# City of Richmond Urban Development Division

Development Permit 04-277201 - 8011 Saba Road

# Report to **Development Permit Panel**

8011 Saba Road

SECTION

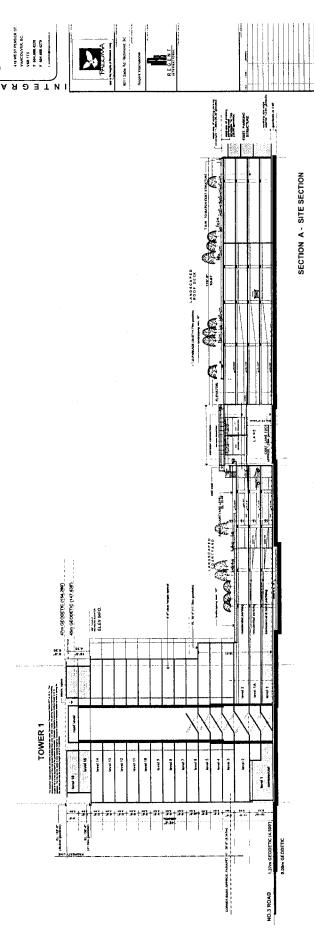
• Carry through the level of detailing and improve the resolution of the surface area between the bank and the proposed tower; and improve the physical connection between the bank and the tower.

(The applicant has enclosed the connection between the bank and the proposed parkade for the towers with an arcade with landscaping on the roof to provide architectural tie-in with the existing building (see section on drawing #14).
